1 [Rincon Hill Area Plan Amendments.]

3 **Ordinance amending the San Francisco General Plan by amending the Rincon Hill Area**
4 **Plan, the Urban Design Element, the Recreation and Open Space Element, the**
5 **Downtown Plan, the South of Market Area Plan, and the Land Use Index to conform**
6 **them with proposed Rincon Hill Downtown Residential District; adopting environmental**
7 **findings that the proposed amendments are consistent with the General Plan and the**
8 **eight priority policies of Planning Code Section 101.1.**

ATTACHMENT A
to the
RINCON HILL GENERAL PLAN AMENDMENTS

1 **Map 3: Land Use Plan**

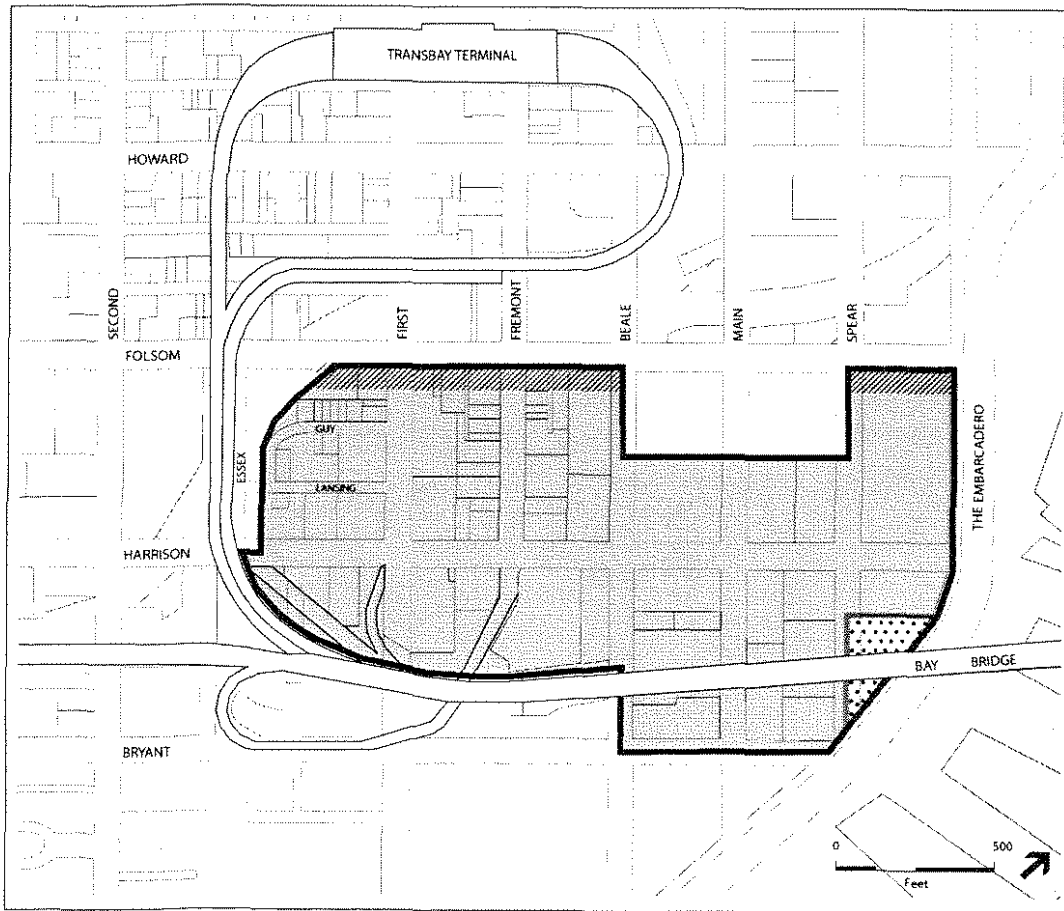
19 1) Replace ~~Map 3: Land Use Plan~~, with new "Map 3: Land Use Plan."

1 **Map 4: Required Ground-Floor Uses**

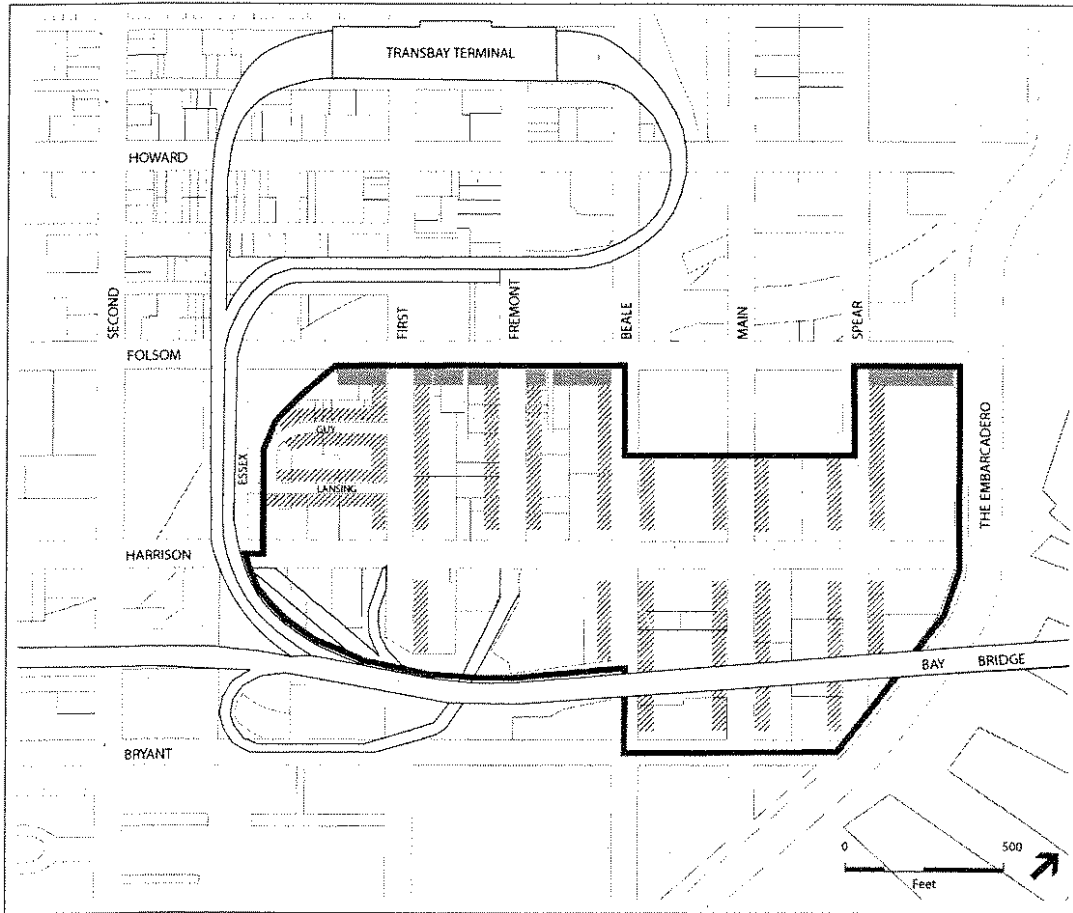
3 Objective 1.5: Add life and activity to the district's public spaces by providing active uses on street-
4 facing ground floors.

20 2) Add new "Map 4: Required Ground-Floor Uses."

1 **Map 7: Height Limits**

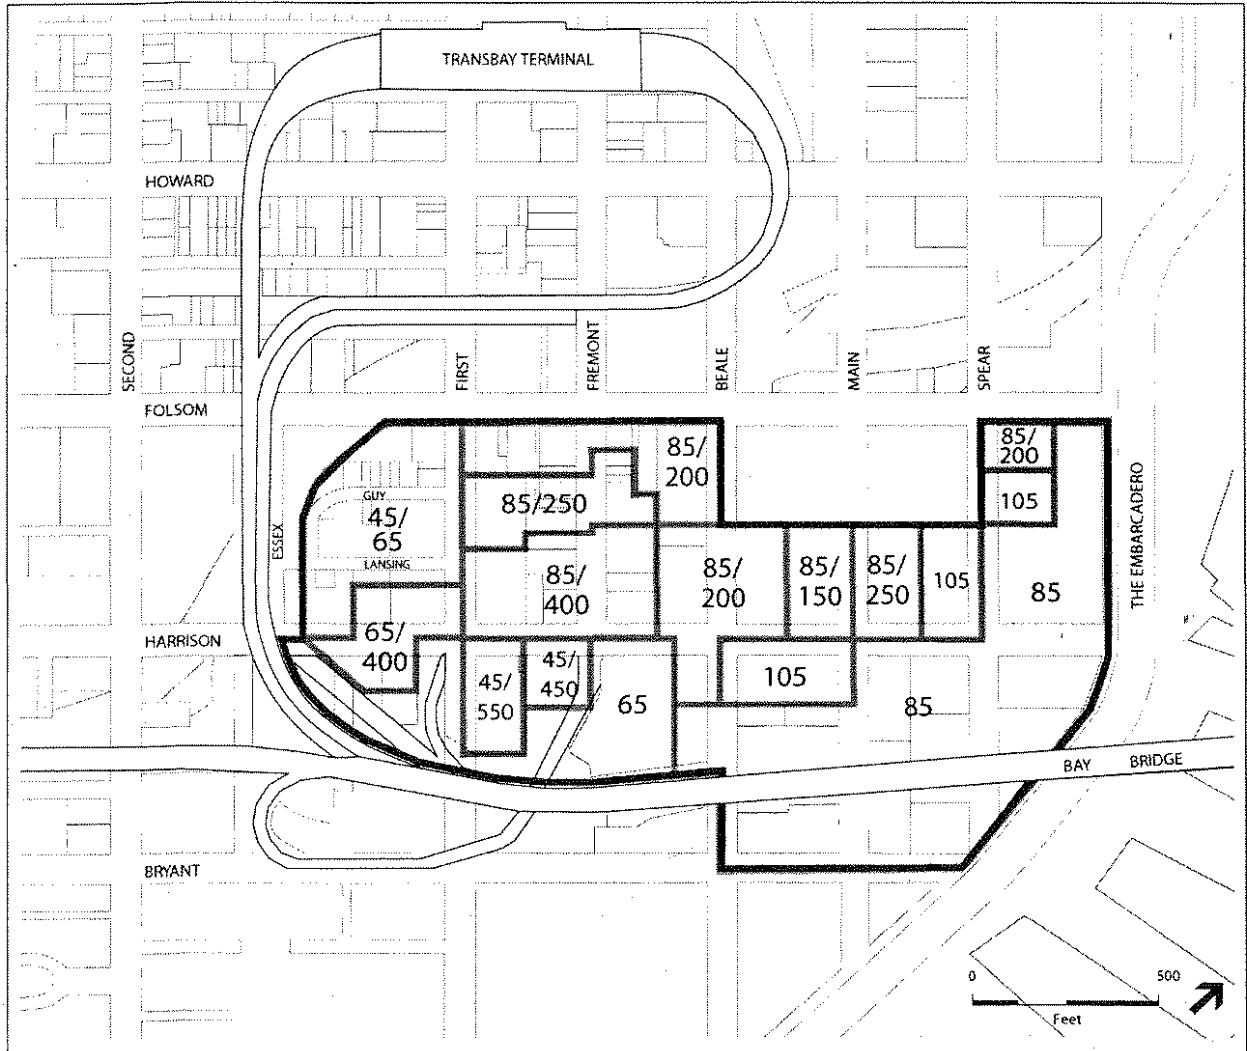
10 Policy 3.10: Provide a consistent 45 to 85 foot streetwall to clearly define the street. See Map 7 for
11 appropriate podium heights for each location within the district.

- 14 1) Replace Map 4: Height Limits with new "Map 7: Height Limits."
- 15 2) Add diagram "Figure 3: Rincon Hill on the San Francisco Skyline," between Objectives 11
16 and 12
- 17 3) Add diagram "Figure 4: Bulk Controls," under Towers Policies.
- 18 4) Add diagram "Figure 5: Required Stepbacks on Streets, Alleys and Mid-Block Passageways,"
19 under Podium and Ground-Floor Policies.

1 **Figure 4: Bulk Control**

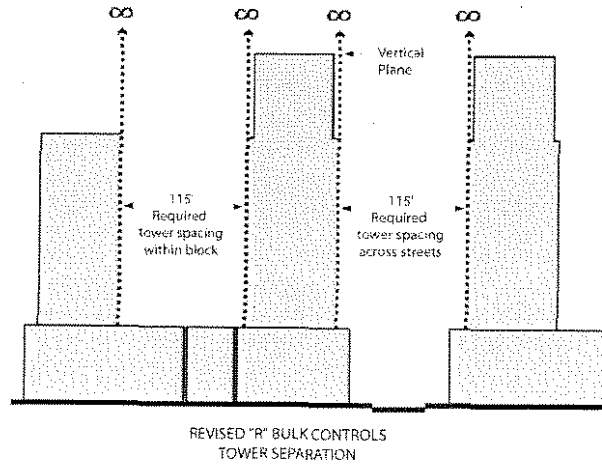
21 Policy 3.3: Minimize tower bulk to the dimensions shown in Figure 4, to ensure a feasible tower
22 floorplate, to create elegant, slender towers and to preserve views and exposure to light and air.

23 Policy 3.4: Require towers to be spaced no less than 115 feet apart, the maximum plan dimension per
24 Figure 4 for towers over 85 feet in height, to minimize shadowing of streets and open space, and to
25 preserve at least as much sky plane as tower bulk.

1 **Figure 5: Required Podium Stepbacks on Streets, Alleyways and Mid-Block**
 2 **Passageways**

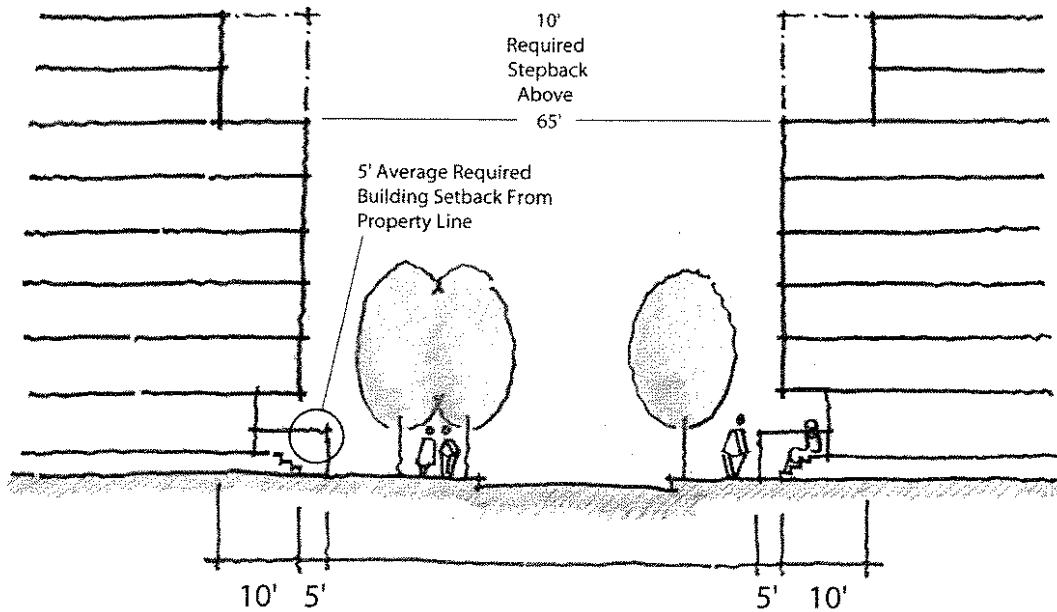
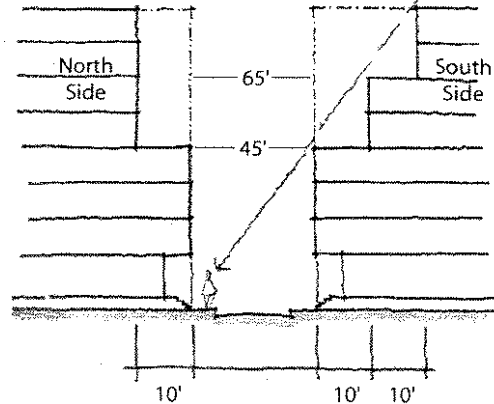
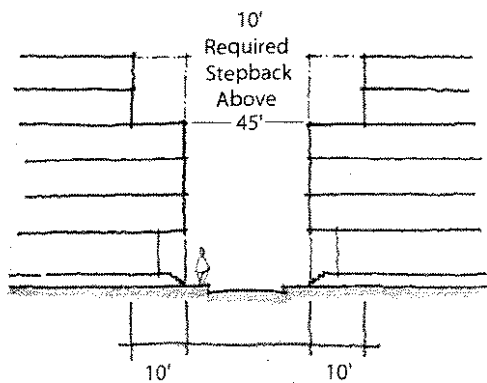
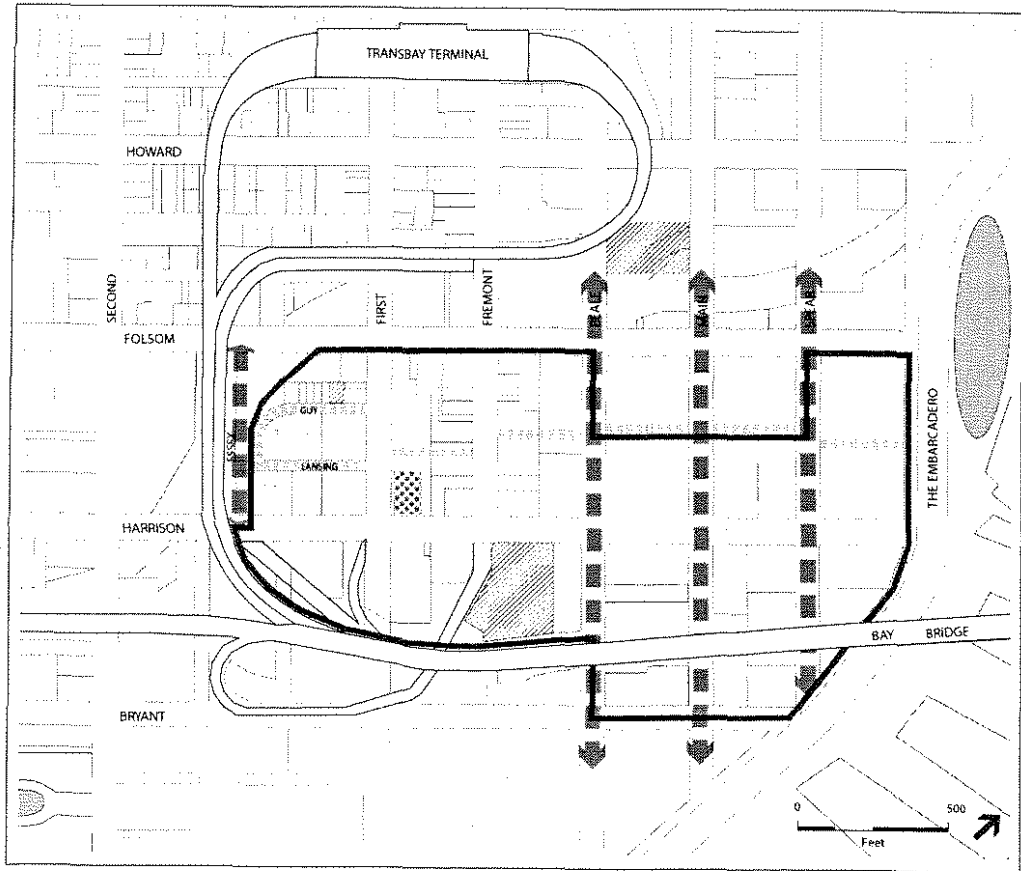
12 Policy 3.11: Require building setbacks at upper-stories for podiums above 65 feet on Spear, Main,
13 Beale, Fremont and First Streets, and above 45 feet on Guy and Lansing Streets and mid-block
14 pedestrian pathways, per Figure 5, to preserve an appropriate scale and sun access to streets.

1 **Map 8: Rincon Hill Public Open Space System**

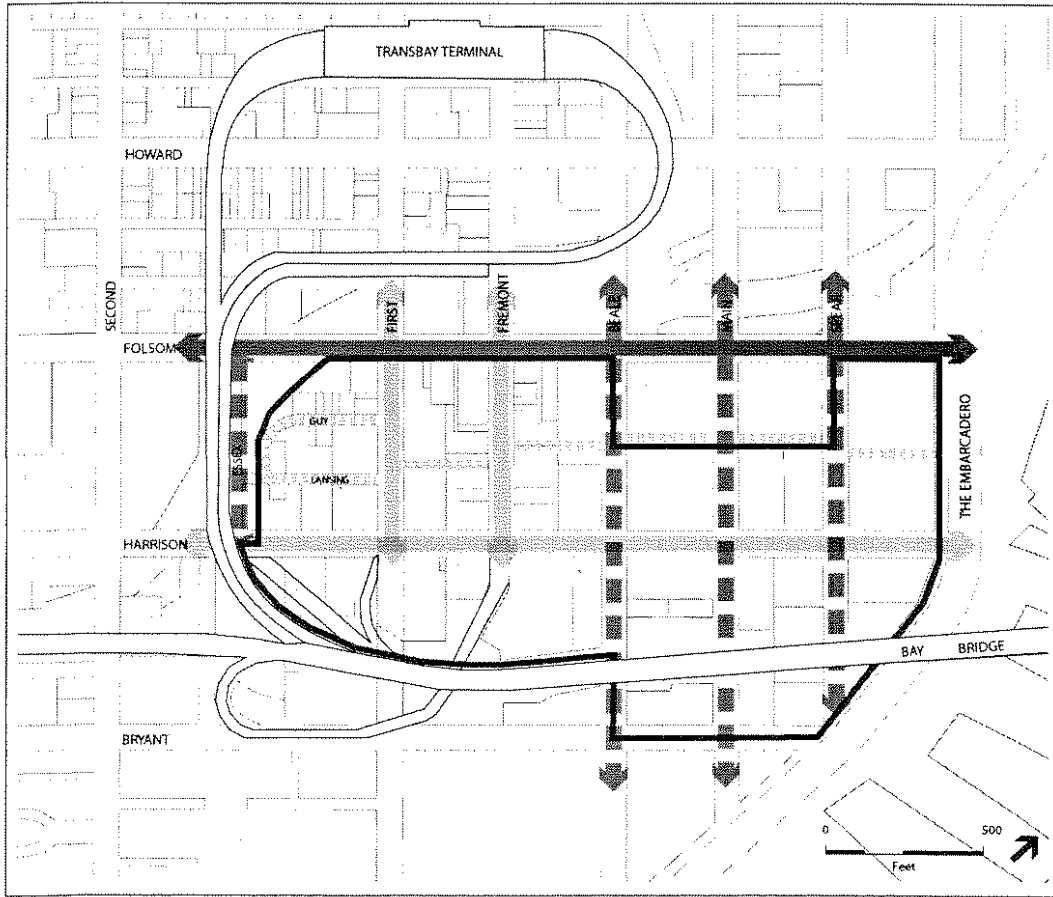
1) Replace ~~Map 5: Publicly Accessible Open Space Opportunities~~ with new "Map 8: Rincon Hill Public Open Space System."

1 **Figure 6: Proposed Living Street Section (Spear, Main and Beale Streets)**

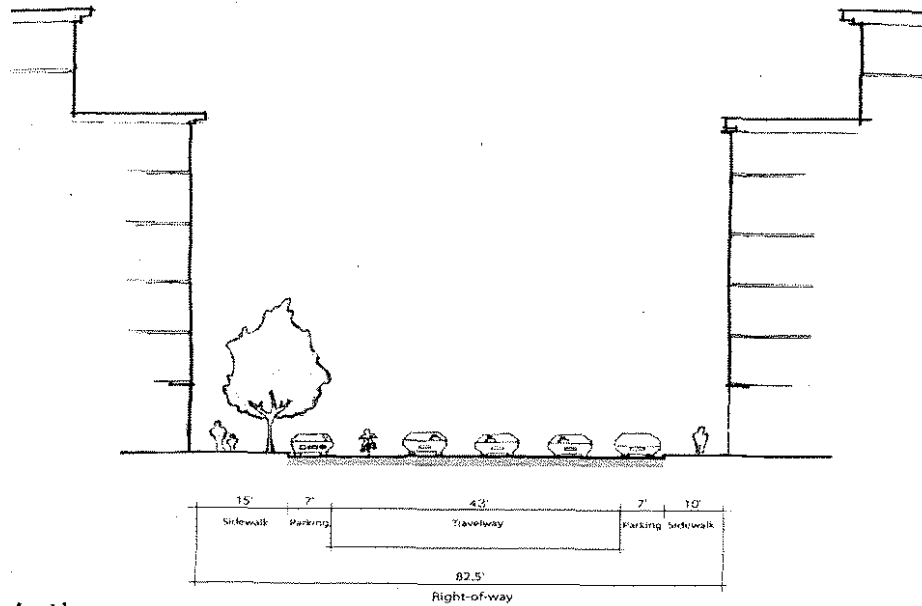
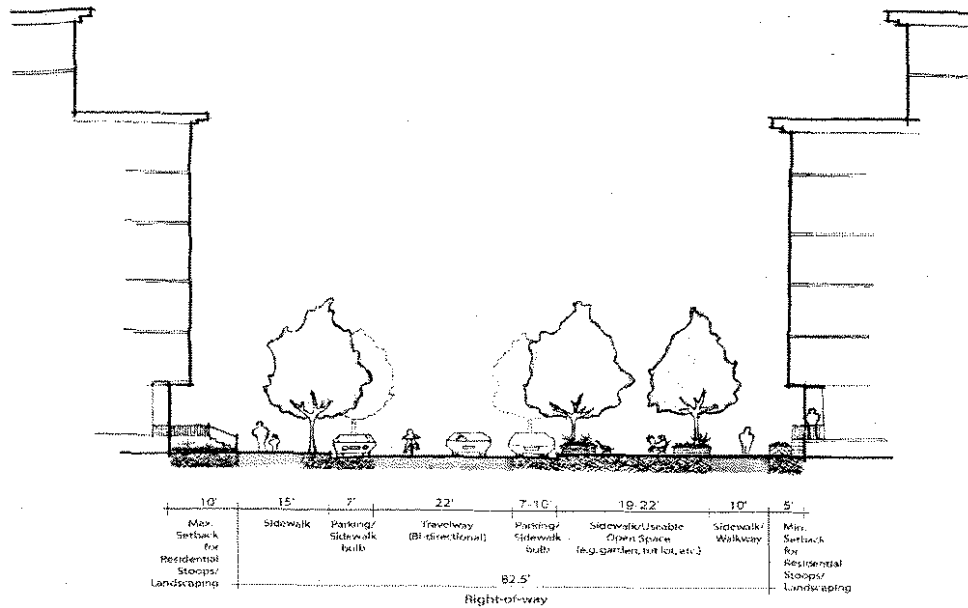
21 Policy 5.2: Significantly widen sidewalks by removing a lane of traffic on Spear, Main and Beale
22 Streets between Folsom and Bryant Streets per the Rincon Hill Streetscape Plan in order to create new
23 "Living Streets," with pocket park and plaza spaces for active and passive recreational use, decorative
24 paving, lighting, seating, trees and other landscaping. See Figure 6.

1 Living Streets prioritize streets for pedestrian activity and open space over auto traffic,
2 providing a variety of open spaces in significantly widened sidewalks, up to 32 feet on one side. The
3 Transbay Redevelopment Plan will continue the Living Street concept north of Rincon Hill, providing a
4 pleasant walk from the Financial District south to the Embarcadero.

- 17 1) Add "Map 9: Rincon Hill Streetscape Concept."
- 18 2) Replace ~~Figure 1: Proposed Street Treatment~~ with new "Figure 6: Proposed Living Street
19 Section (Spear, Main and Beale Streets)."
- 20 3) Delete ~~Map 6: Pedestrian Street Location~~
- 21 4) Delete ~~Figure 2: Row House Design~~
- 22 5) Delete ~~Figure 3: Rooftop Open Space Over Intercept Parking~~

Areas for New Housing Near Downtown

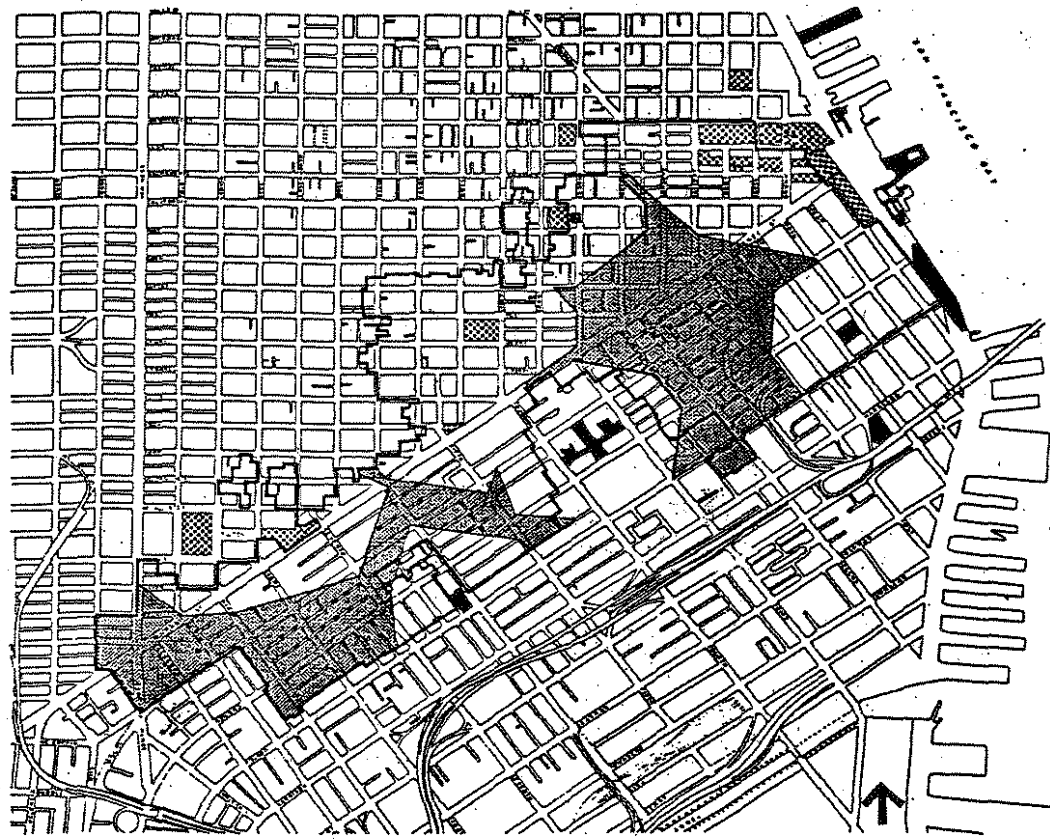
7 Expand the shading of Areas for New Housing Near Downtown to the east and to the south to
8 reflect the changes proposed in the Rincon Hill plan.

Major Open Spaces

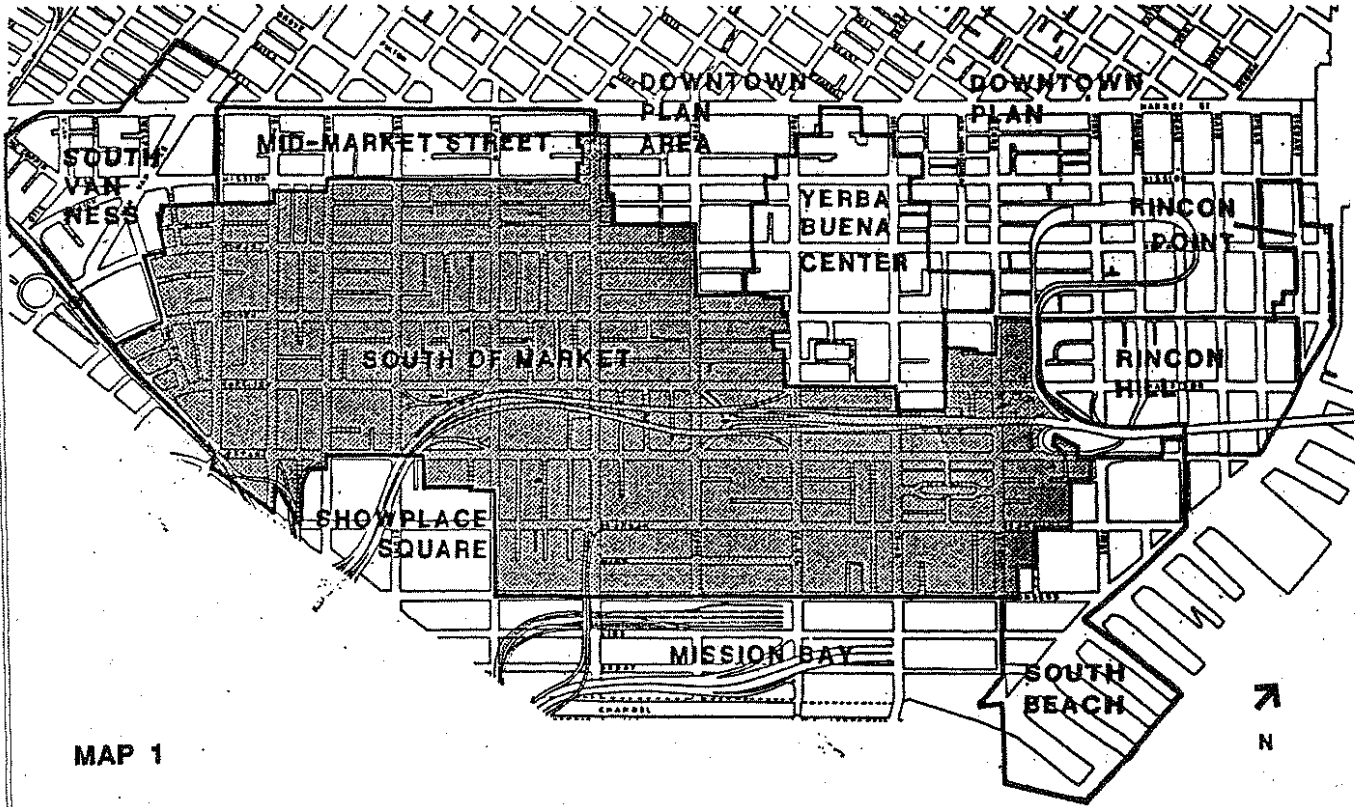
10 Amend map to include the proposed open space at Harrison and Fremont Streets (Block 3766,
11 Lot 009) as "open space in the planning stage."
